Bill of Materials Backline 112/110 Preamp 206-0150-A

APPROVALS	DATE	TITLE
INT	10/10/01	BACKLINE 110/112 PRE-AMP
DESIGNED: R.A.G.	12/21/01	DRWING NO: 406-0150-A2
DRAWN: R.A.G.		PART NO: 206-0150-A2
ELEC:		COMPANY: GALLIEN-KRUEGER
MECH:		FILENAME: 6150A2 Backline 112 Preamp.sch
S/A:		
RELEASED:

L. CHANGE ALL POTS TO BRACKET STYLE.		APPROVALS		TITLE: BACKLINE 110/112 PRE-AMP	
INIT	DATE				
DESIGNED: R.A.G.	10/01/01			DRAWING NO: 406-0150-B2	REV. B2
DRAWN: R.A.G.	9/10/02			PART NO: 206-0150-B2	
ELEC:					
MECH:				COMPANY: GALLIEN-KRUEGER	
D/A:				FILENAME: 6150B2	
RELEASED:

1. CHANGE R5 TO 10.0K FROM 8.25K.		APPROVALS		TITLE: BACKLINE 110/112 PRE-AMP	
2. UPDATE ALL PAD AND HOLE SIZES.		INIT	DATE	DESIGNED: R.A.G.	10/01/01
3. CHANGE BOARD NO. TO 206-0191-A FROM 206-0150-B2.		DRAWN: R.A.G.	12/6/02	DRAWING NO: 406-0191-A	REV. A
		ELEC:		PART NO: 206-0191-A	
		MECH:		COMPANY: GALLIEN-KRUEGER	
		D/A:		FILENAME: 6191A	
		RELEASED:

Bill of Materials Backline Pre Amp 206-0150-A3

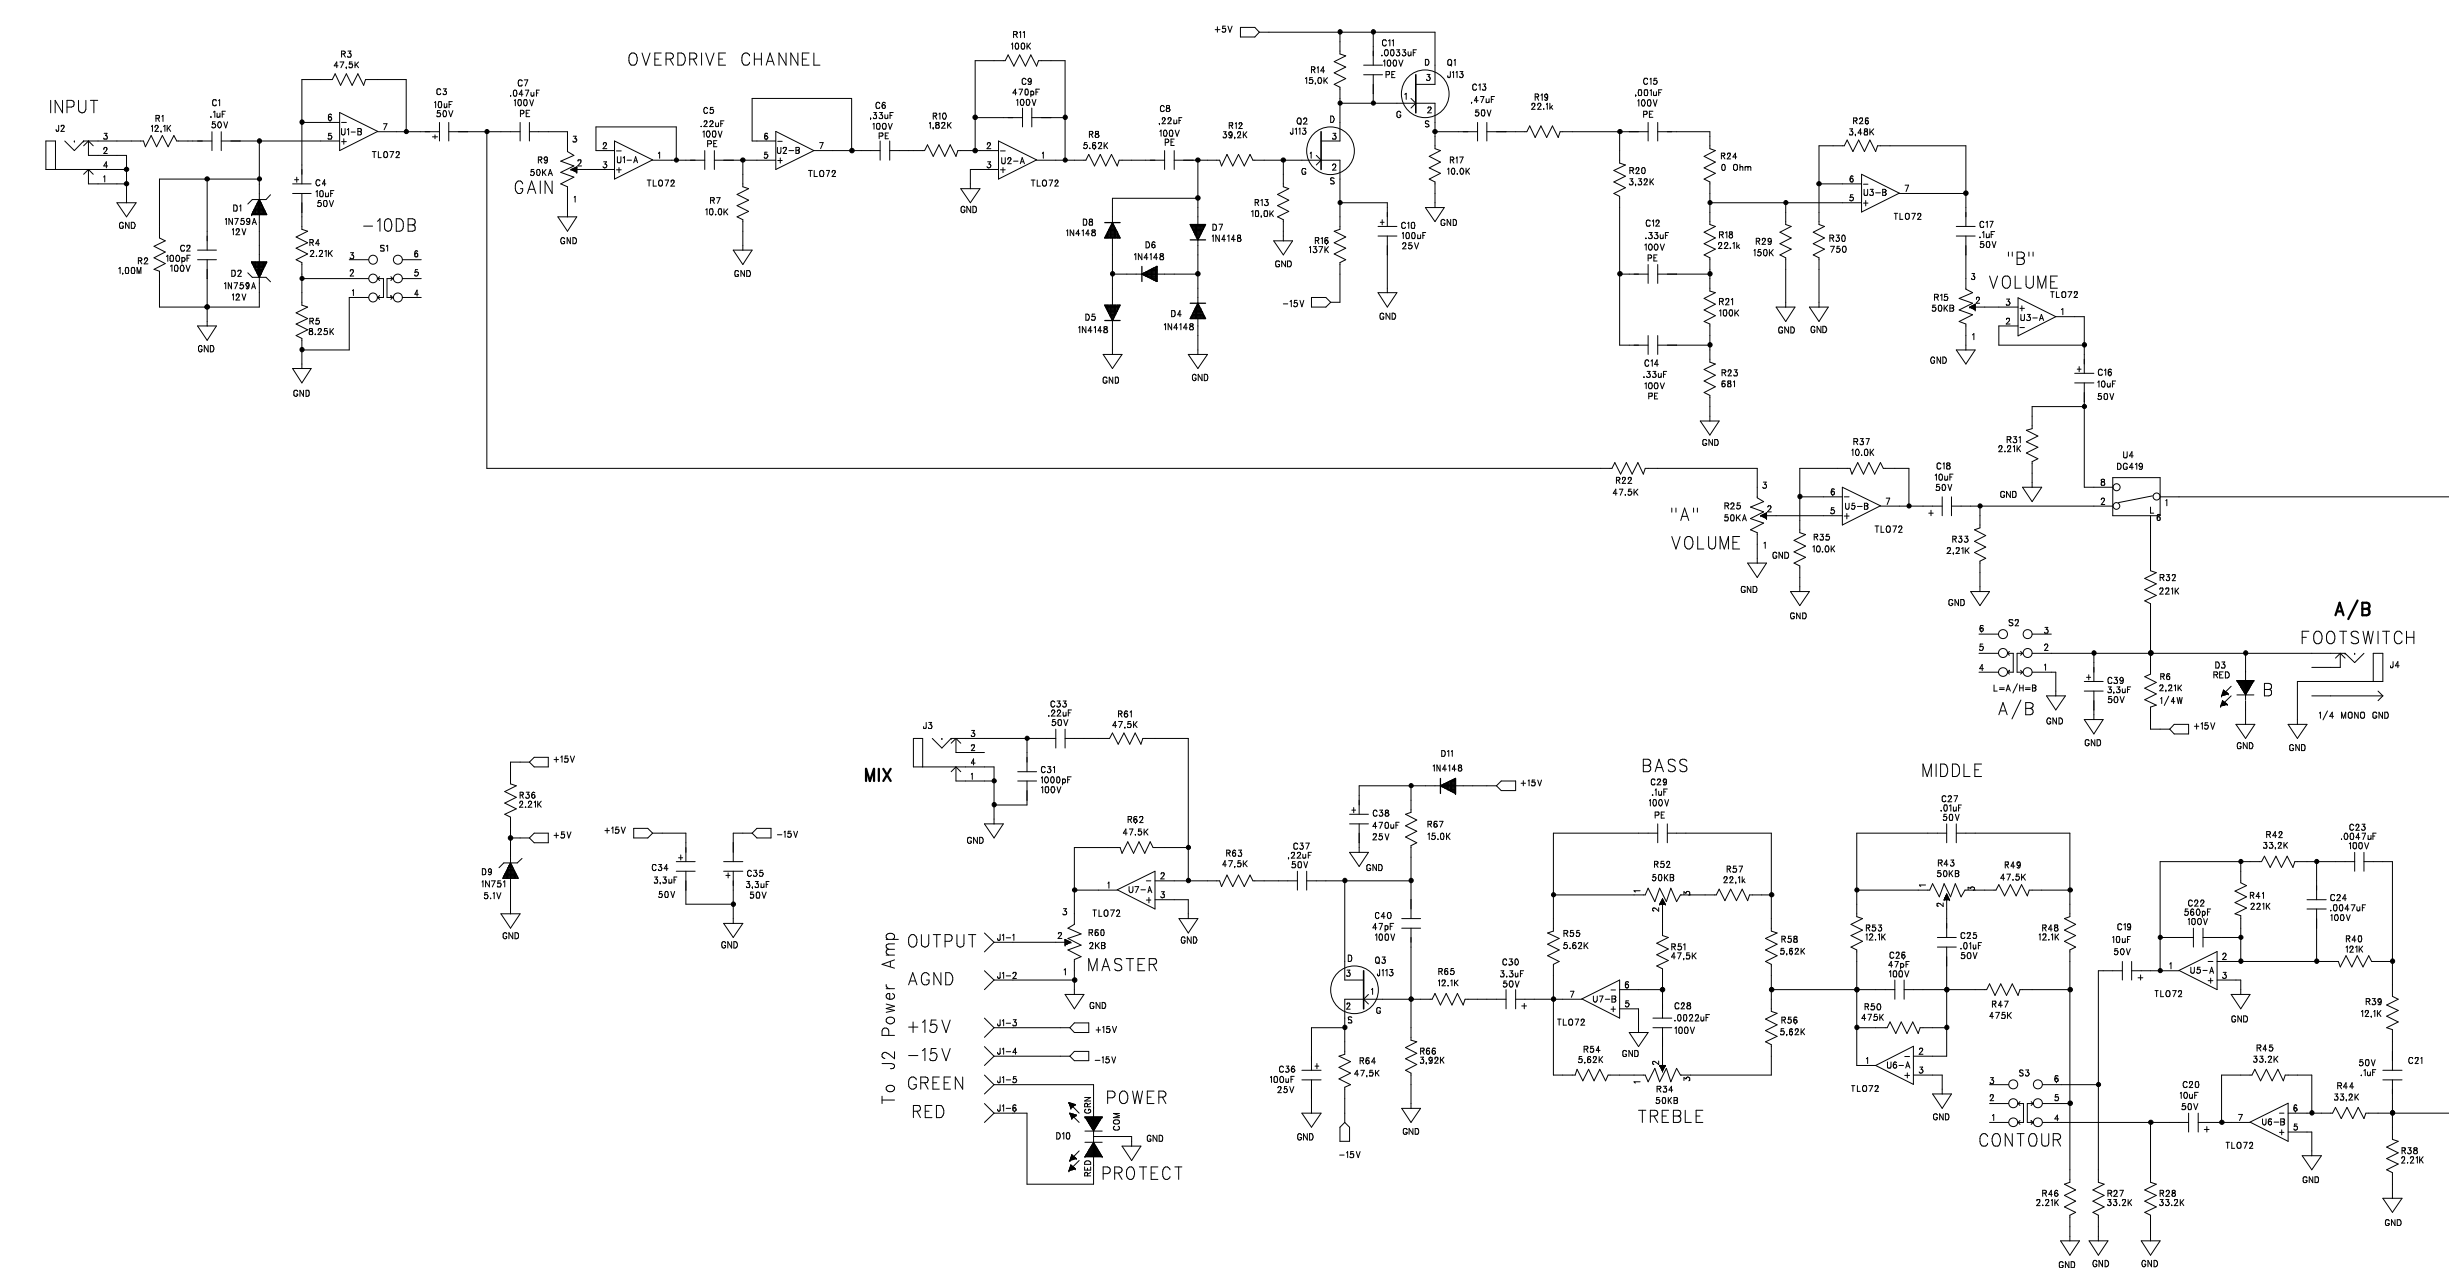
1. Remove R59 and C32.		APPROVALS		TITLE: BACKLINE 110/112 PRE-AMP	
INIT	DATE				
DESIGNED: R.A.G.	10/01/01			DRAWING NO: 406-0150-A3	REV. A3
DRAWN: R.A.G.	3/26/02			PART NO: 206-0150-A3	
ELEC:					
MECH:				COMPANY: GALLIEN-KRUEGER	
Q/A:				FILENAME: 6150A3 Backline 112 Preamp.sch	
RELEASED:

Backline 112 Preamp 206-0150-B

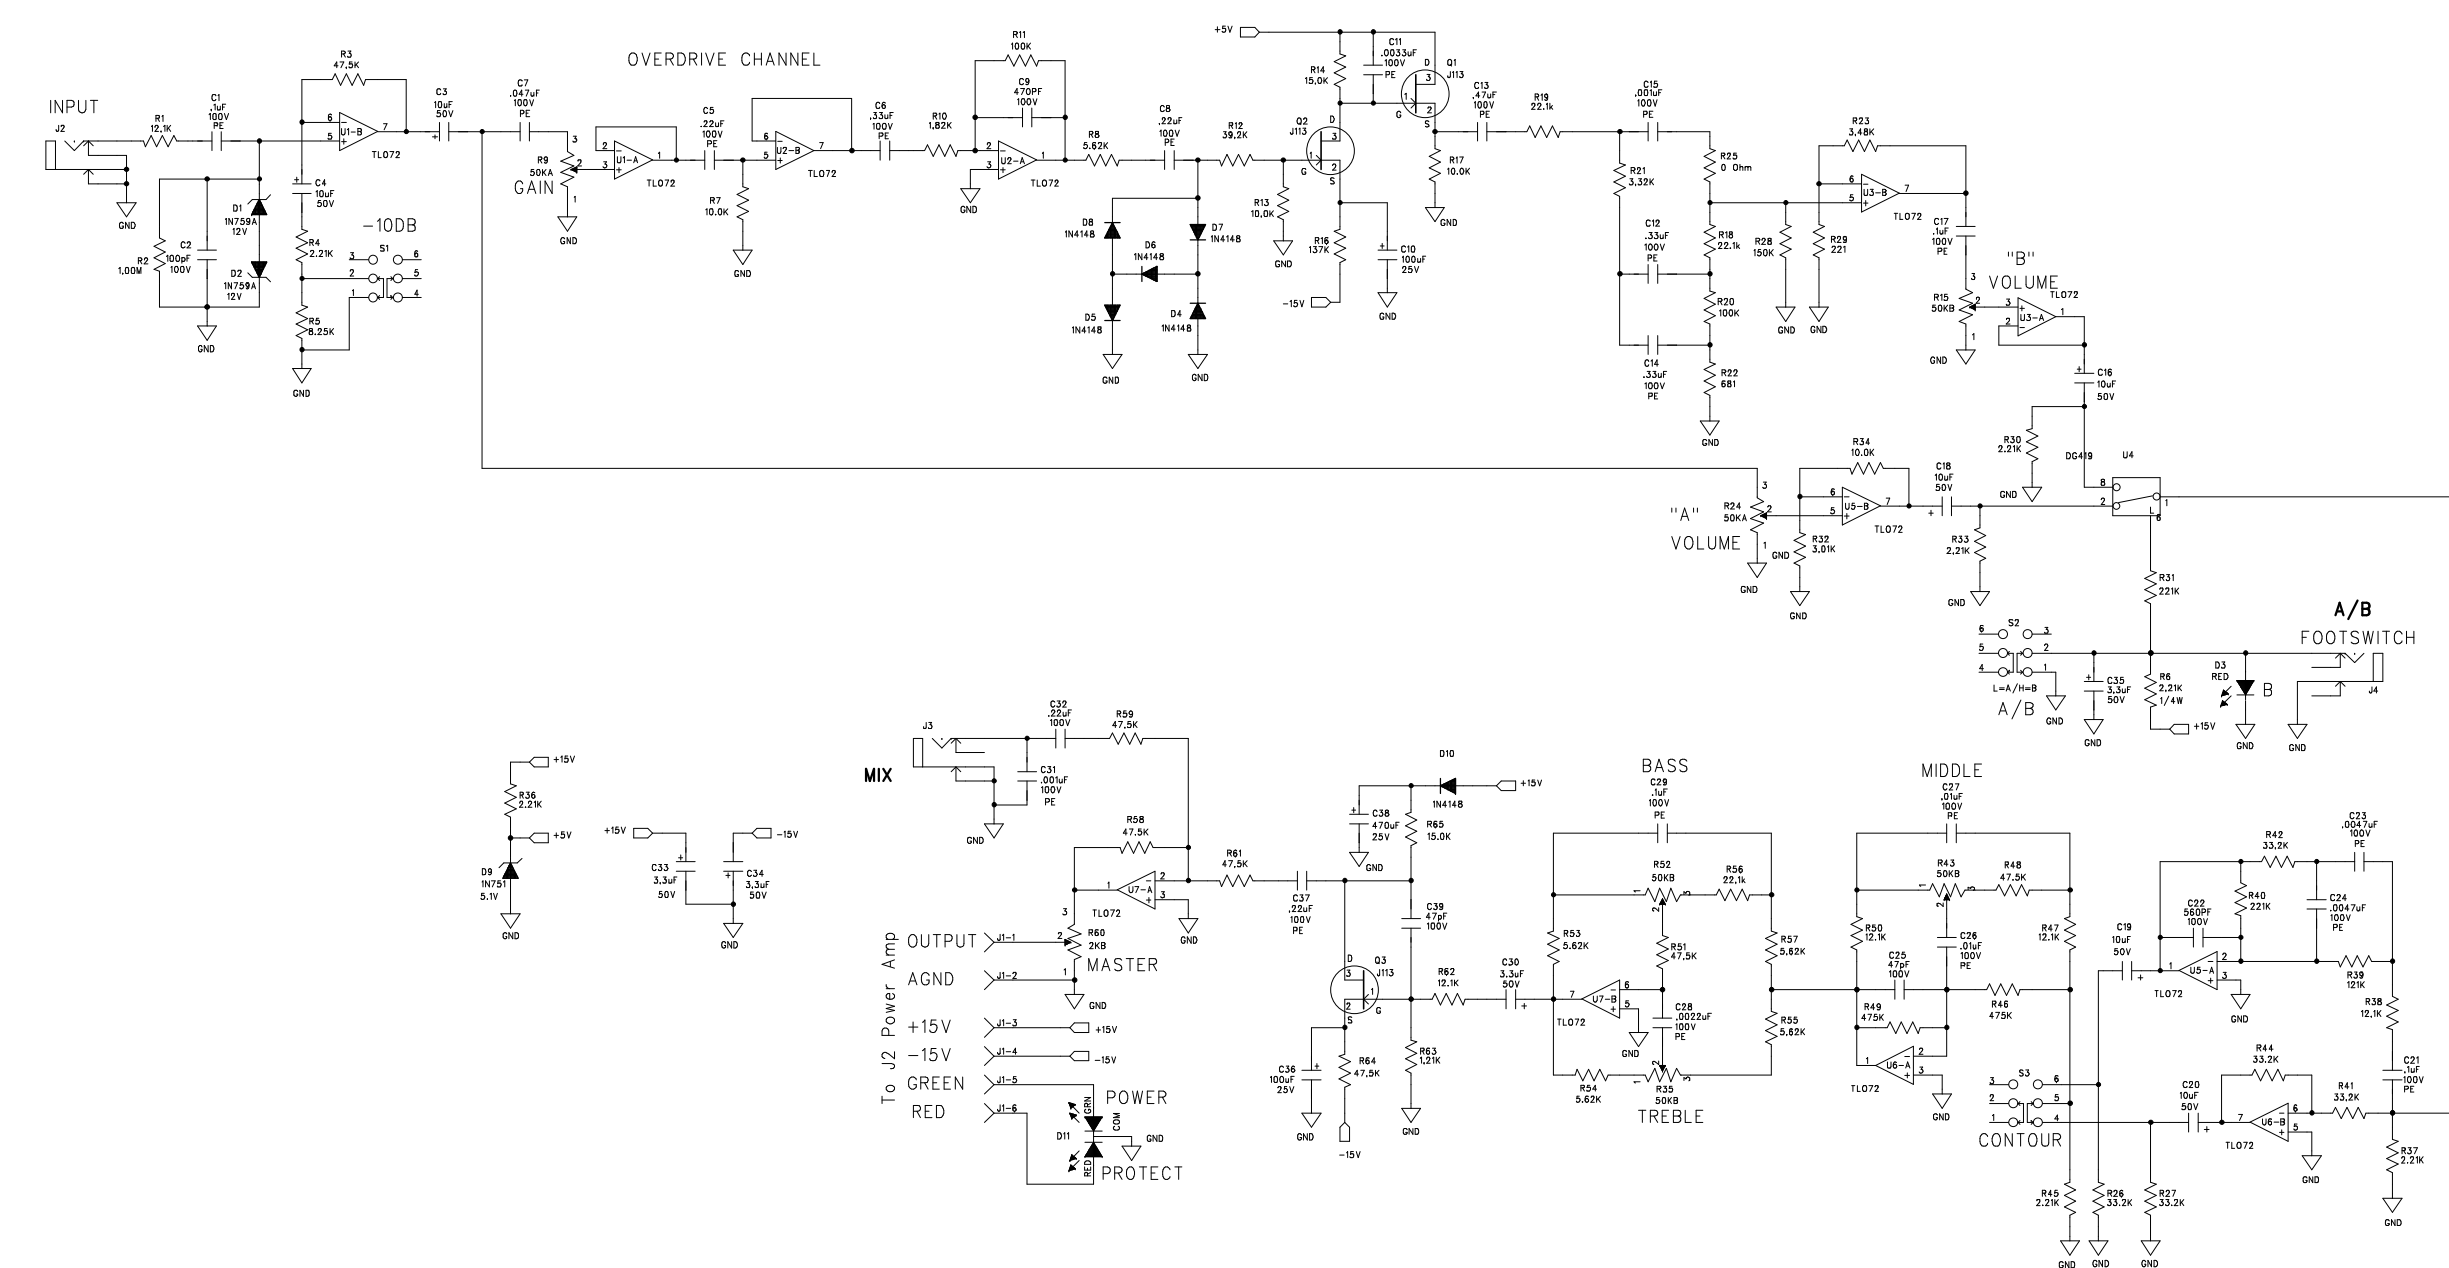
1. Change all axial ceramic caps to polyester or radial ceramic.		APPROVALS		TITLE: BACKLINE 110/112 PRE-AMP	
DESIGNED: R.A.G.	DATE: 10/01/01	INIT	DATE	DRAWING NO: 406-0150-B	REV.
DRAWN: R.A.G.	DATE: 5/28/02			PART NO: 206-0150-B	B
ELEC:				COMPANY: GALLIEN-KRUEGER	
MECH:				FILENAME: 6150B	
Q/A:					
RELEASED:

- Change all axial ceramic caps to polyester or radial ceramic.
- Enlarge transformer notch to end of board and make .1 inch deeper.
- Change R30 to R29 = 221.
- Change R35 to R32=3.01K
- Change R 66 to R63=1.21K
- Delete R22 from rev A3.

APPROVALS		TITLE:		REV.
INIT	DATE	BACKLINE 110/112 PRE-AMP		
DESIGNED: R.A.G.	10/01/01	DRAWING NO:	406-0150-B1	B1
DRAWN: R.A.G.	8/28/02	PART NO:	206-0150-B1	
ELEC:		COMPANY:	GALLIEN-KRUEGER	
MECH:		FILENAME:	6150B1	
Q/A:				
RELEASED:

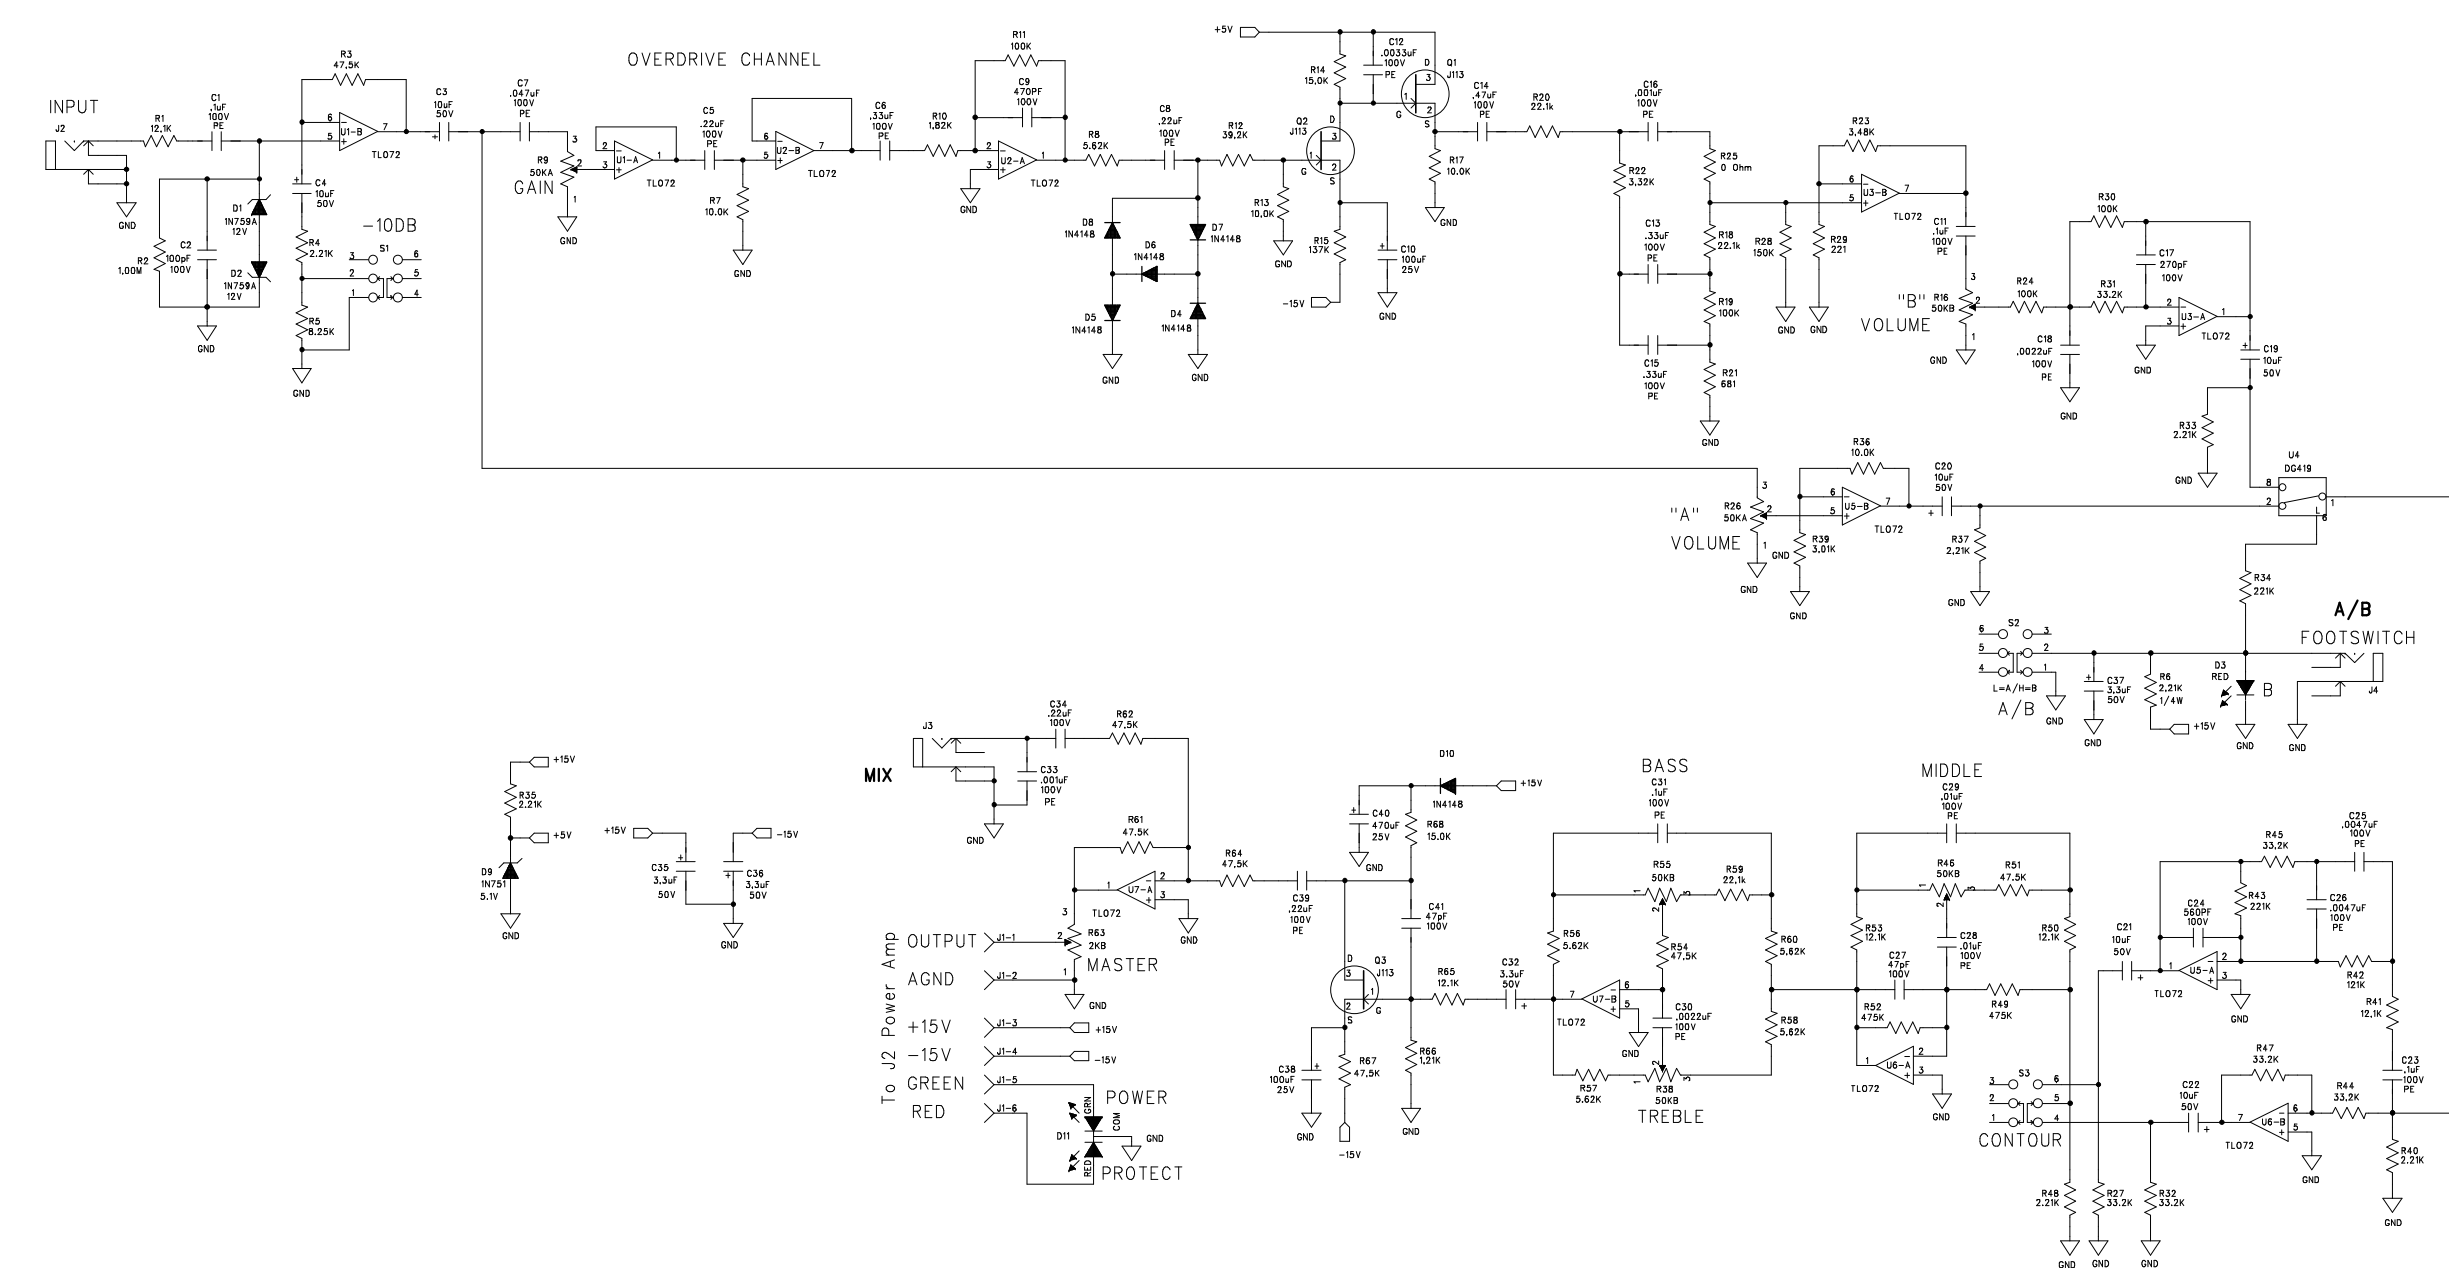
1. ADD CAB SIMULATOR CKT TO USA.

DWG #420-0150-B2

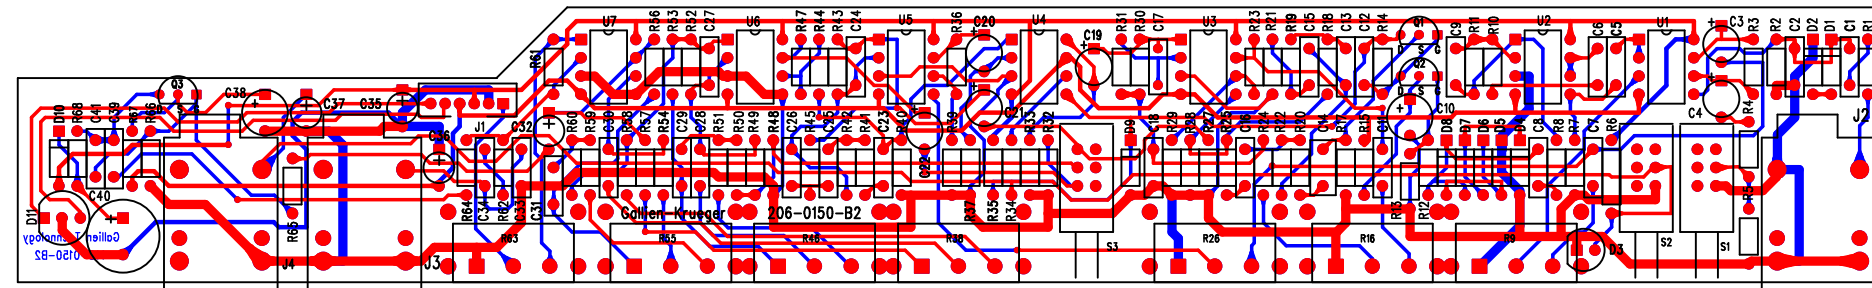
5. CLIP BUSHING TABS OFF ON POTS R9, 16, 26, 38, 46, 55, 63
6. SEE DETAIL A FOR MOUNTING D3
7. SEE DETAIL "B" FOR MOUNTING D11
8. CLIP BRACKET FROM RIGHT SIDE OF R9 TO CLEAR D3.
